# Enhancing Robustness of Link Synchronization in Automotive Ethernet at 802.3cy-Part II

802.3cy TF, Jan interim meeting, 2022

# Proposed scheme at Nov, 2021meeting (Multiple Frame at Slave)

Transition `TX_SEND_S -> SIGDET_WAIT`, condition for transition is modified

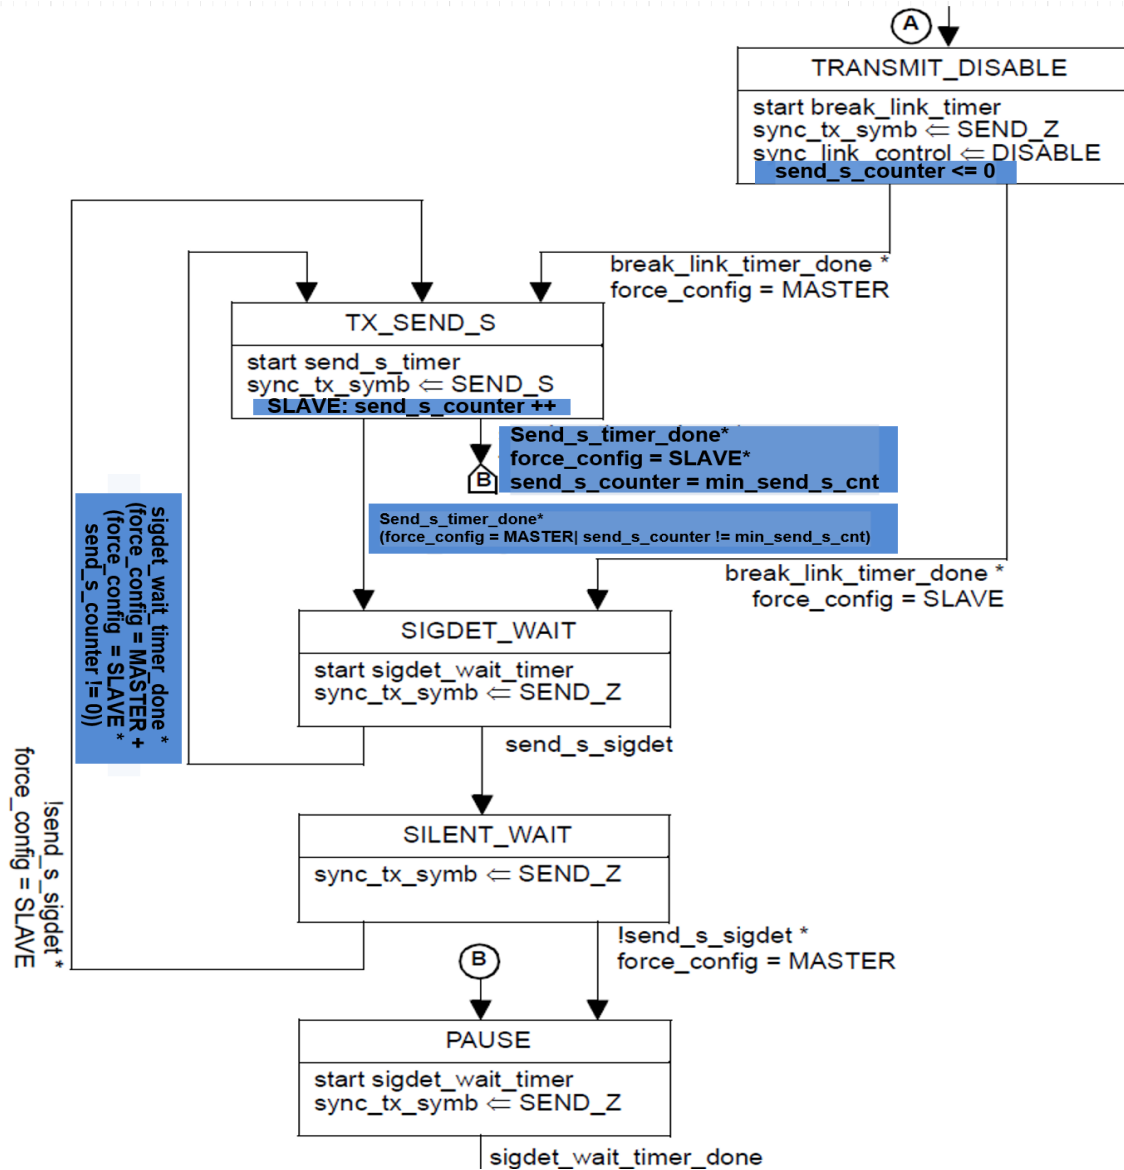
- Simplification the scheme:
  - `min_send_s_cnt = 16`, fixed value, not programmable
- clarification on state transition

from:

```
send_s_timer_done * (force_config = MASTER | send_s_counter != min_send_s_cnt)
```

to:

```
send_s_timer_done * ((force_config = MASTER) + (force_config = SLAVE) * (send_s_counter != min_send_s_cnt))
```

updated state diagram

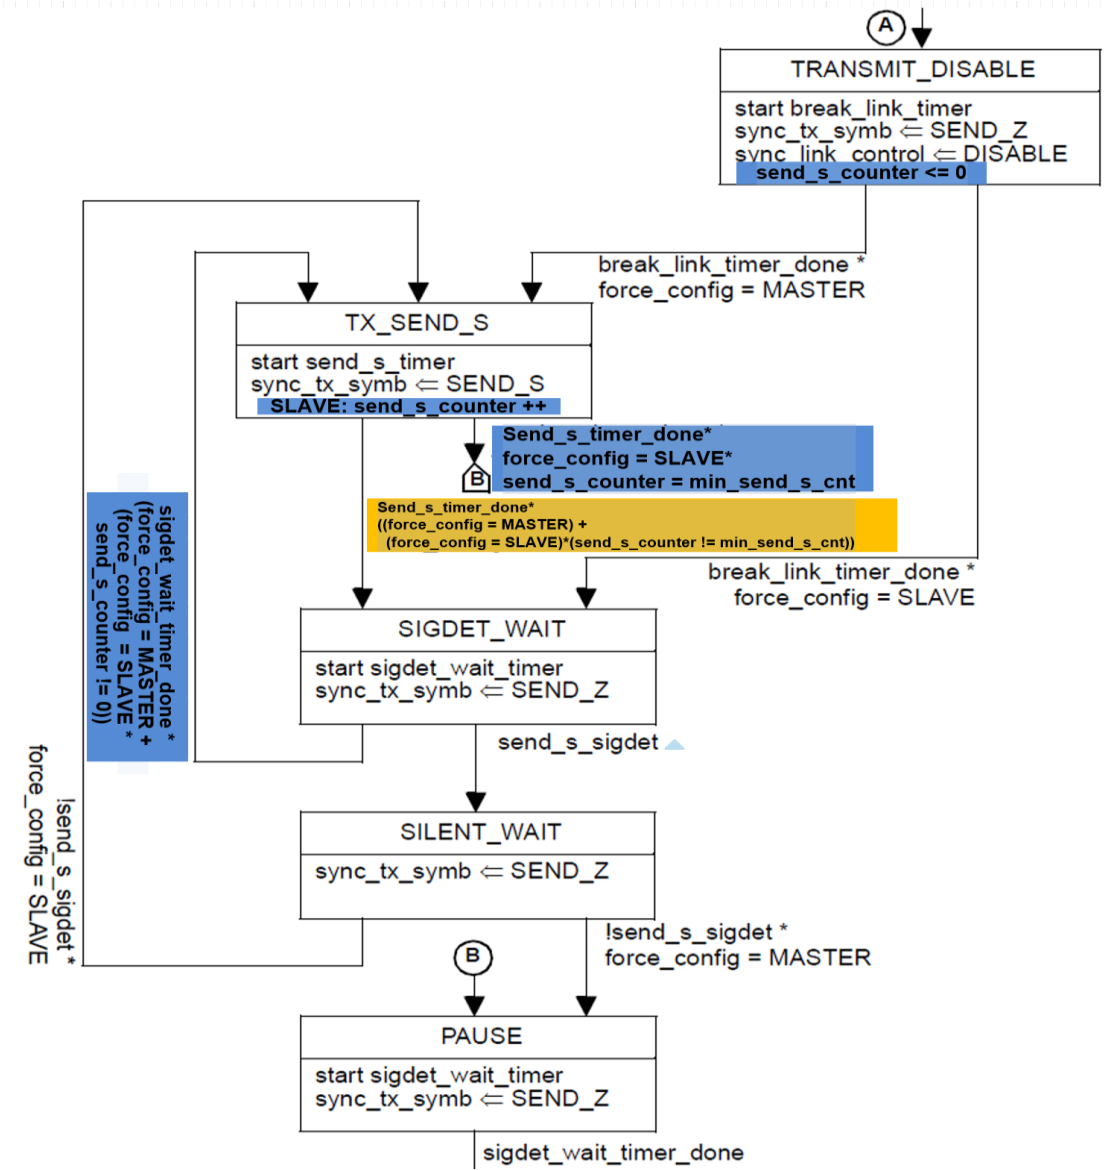
# State transition update:
